Federal “Good Neighbor Plan” for the 2015 Ozone National Ambient Air Quality Standards

Response to Public Comments on Proposed Rule [87 FR 20036, April 6, 2022]

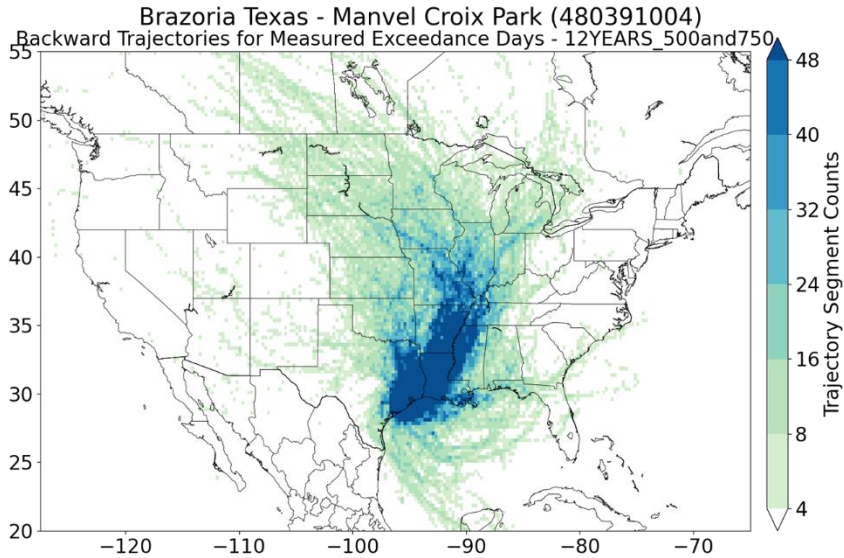
Commenter (0798) states EPA’s CAMx modeling only looked at five to ten elevated ozone days and did not evaluate where the ozone and precursors arose that contributed to those days. To evaluate whether the U.S. Steel facilities in Arkansas could contribute to any of these ozone high events identified by the EPA, the commenter used HYSPLIT to calculate seventy-two hour back-trajectories for the EPA’s top-ten CAMx predicted maximum daily 8-hr 2026 ozone events for the ozone monitoring site located in Brazoria, Texas. The top three ozone days had contributing air parcels originating well outside of Arkansas, or only briefly passing through the very southern section of Arkansas, and in no event originated or passed through the northeastern portion of Arkansas where the U.S. Steel facilities are located. As a result, the

U.S. Steel Arkansas facilities did not contribute to any of the events assessed by the EPA, and thus cannot be said to significantly contribute to any maintenance issues evaluated by the EPA at the Brazoria receptor. The commenter is also in the process of performing confirmatory CAMx modeling to determine the source specific contributions to the Brazoria monitor which EPA neglected to evaluate. CAMx modeling can take significant time to complete, and although we are diligently pursuing this modeling, it is impossible to complete before the June 21 comment deadline. However, because the necessity of this modeling was created by the EPA's failure to perform and/or disclose source-specific CAMx contribution modeling and unreasonably truncated public comment period, and because it bears directly on the EPA's authority to regulate U.S. Steel at all under the good neighbor provision, the EPA must consider this modeling whenever it is completed in determining applicability of any final rule to U.S. Steel facilities without running afoul of the CAA.

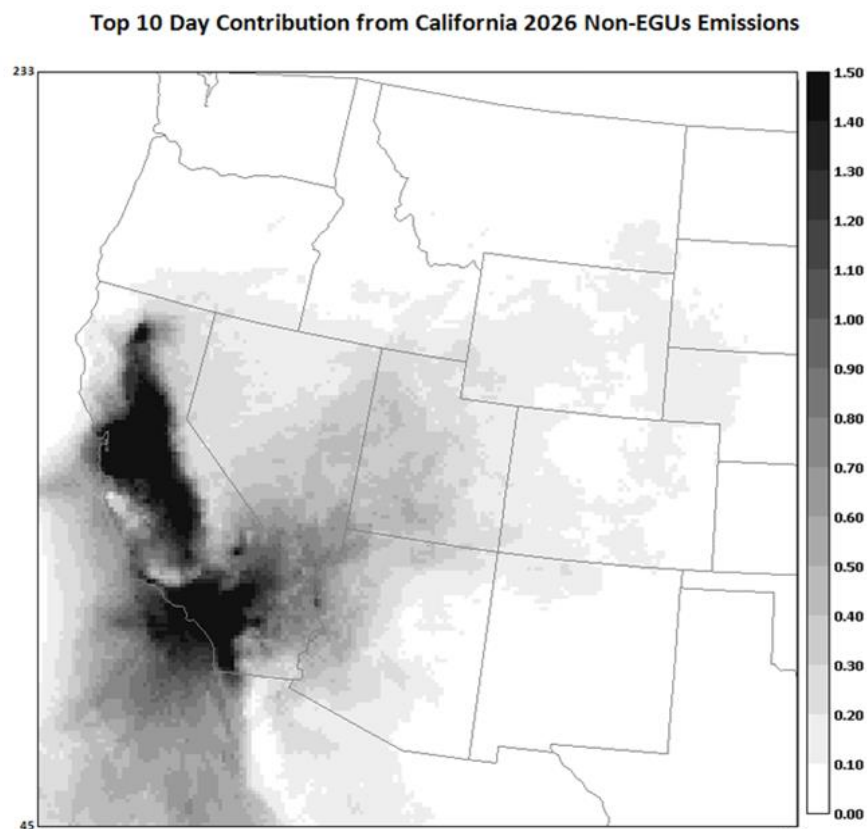
Commenter (0237) states the FIP package issued by the EPA lacks detailed documentation for the California non-EGU source impacts at the nearby receptors. The commenter (in comment #2) notes that detailed source-specific data has not been provided for NO_x emissions reductions postulated for CA non-EGUs and for whether these reductions are significant and worthwhile, and therefore, the June 5 deadline for FIP comments becomes invalid. The commenter also states (in comment #7) that FIP failure to address CA SIP and mobile source contributions. ARB projects that the CA SIP is adequate for avoiding interstate transport (IT) impacts, and the FIP is not needed for CA sources. Any IT rule affecting Southern California needs to consider South Coast Air Basin transport to other air basins and to the Yuma Arizona monitor. The South Coast Air Basin is closer to and directly upwind of the Yuma Arizona monitor, whereas the CA non-EGU sources selected are further away and not upwind. Any IT rule affecting California needs to consider the largest NO_x sources in CA that impact attainment inside CA, and then evaluate how these sources will impact attainment in downwind states, for example, mobile sources (as postulated in the CA SIP).

Commenter (0303) states SoCal non-EGU sources have no projected impacts on any monitors other than Yuma, Arizona. Therefore, the SoCal non-EGU sources do not meet the FIP applicability criteria as set forward by the EPA elsewhere in the FIP package of documents (namely impacts on more than one monitor).

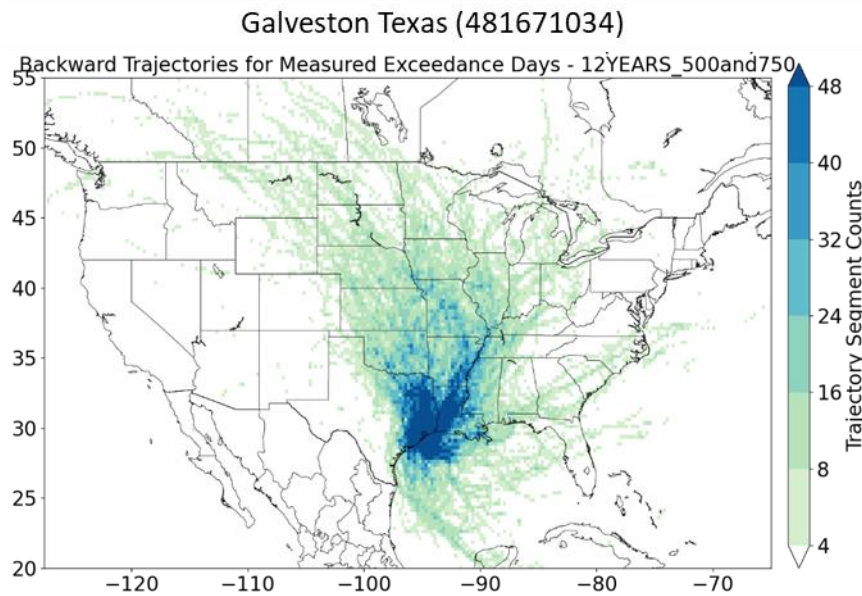
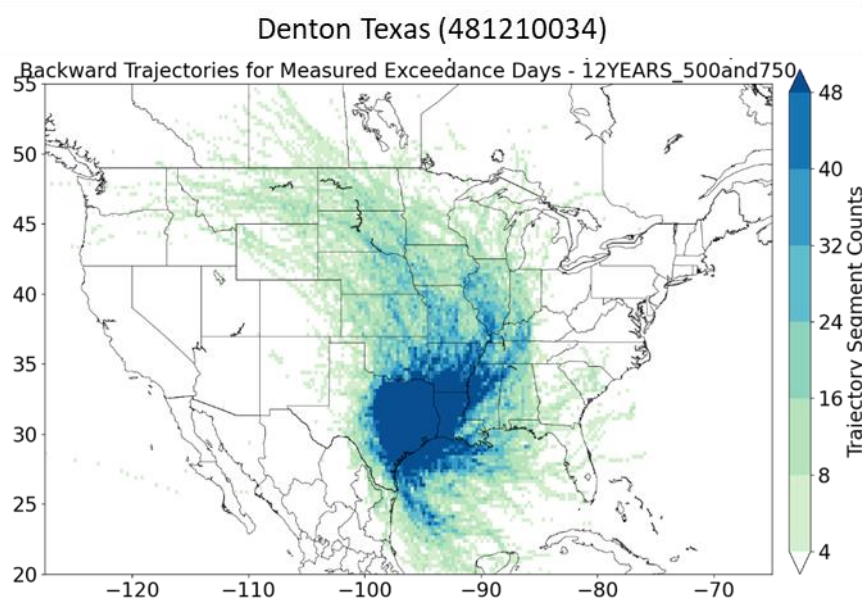
Commenter (0300) provides multiple figures showing wind roses from Houston Intercontinental Airport. They show wind speed and direction during the three-year period 2018-2020. 72-hr back trajectories demonstrate stagnant conditions resulting in a minimum distance traveled over the past 72 hours. According to the commenter, the majority of the winds blow from the south and south/southeast. Less than 2 percent of the duration does the wind blow from the east/east-northeast (*i.e.*, from Mississippi, geographically). Commenter (0542) states that Texas is geographically located upwind of Mississippi. Review of

meteorological data indicates most occurrences of high ozone days in the Texas receptors occurred under stagnant conditions, not on the rare instances when the wind was blowing from east to west.

The EPA found that emissions in Mississippi were linked to downwind receptors in Brazoria County (monitoring site 48031004), Denton County (monitoring site 481210034) and Harris County (monitoring site 482010055), TX based on the 2016v2 modeling. The commenter claims that Mississippi should not be identified as linked to these receptors because they claim that air is very stagnant on days with measured exceedances at these receptors and air rarely moves from Mississippi west toward Texas on exceedance days. The commenter relies upon analyses of near ground-level wind flow (*i.e.*, wind roses) and HYSPLIT-based multi-day back trajectories on days with measured exceedances at these receptors to support their claims that Mississippi should not be linked to these receptors.

The EPA disagrees that the Agency should conclude that sources in Mississippi do not contribute to nonattainment or maintenance receptors in Texas. First, regional pollutant transport occurs when ozone precursor emissions (*i.e.*, NO_x and VOCs) from sources in an upwind state are emitted into the air and form ozone. The photochemical reactions that form ozone also form “by-product” pollutants that are “recycled” to form additional ozone farther downwind. The ozone and by-product pollutant species are vertically mixed due to dispersion and updrafts/downdrafts within the daytime boundary layer (*i.e.*, the mixed layer) during the day. Variations in wind speed and direction between the ground and the mid-to-top of the daytime mixed layer can result in different transport patterns aloft than near the ground. In addition, pollutants formed during the day that remain aloft over night or are emitted aloft during the night above the very shallow nighttime surface layer can be transported long distances due to the effects of the “nocturnal jet,” which is a high-speed ribbon of air that forms above the top of the nighttime surface layer. In addition, wind speed typically increases with height within the mixed layer, because the effects of surface roughness, which reduces wind speed near the ground, diminishes with height. Pollutants transported downwind aloft are typically brought down to the ground on subsequent days beginning in mid-morning as the height of the mixed layer rises. By this process pollutants transported aloft from upwind states can contribute to high ozone concentrations at monitoring sites in downwind states. While wind roses and trajectories based on data near or within a few hundred meters of the ground are useful for analyzing local scale transport (*i.e.*, within an urban area) such analyses generally will not provide particularly reliable or meaningful information on long-range, multi-day transport of ozone and by-product pollutants aloft.
